Re: Permit Application P34800
Catani Gardens, St Kilda (VHR H1805)

This letter has been prepared on behalf of Parks Victoria in relation to the permit application to establish a temporary works compound in the southern end of the Catani Gardens for use during the redevelopment of the St Kilda pier. Heritage Victoria have expressed a number of concerns arising from the application and have requested additional information, as listed and addressed below.

Indicative images of temporary fencing proposed for the construction compound.

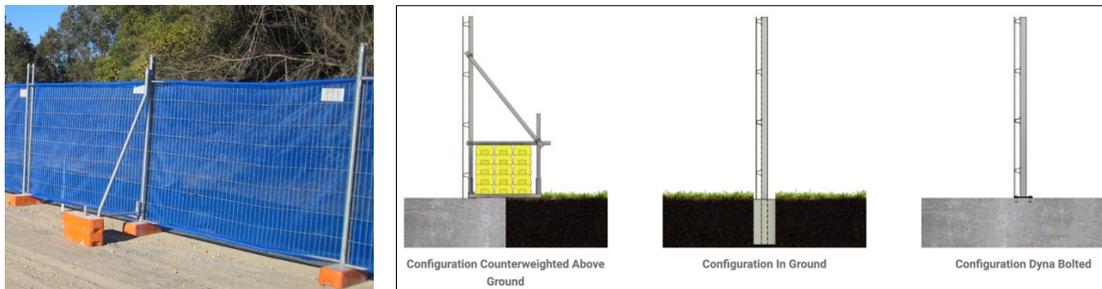
- *Details of the fencing/hoarding around the compound and any graphics or images that may be placed on printed wrap fixed to the fence/hoarding as suggested in the HIS.*

Aside from the issue of the artwork, the temporary fencing to the proposed construction compound will be of a standard type of approximately 1.8-2.1 metres in height. The typical appearance and fixing details for the temporary fencing are illustrated below.
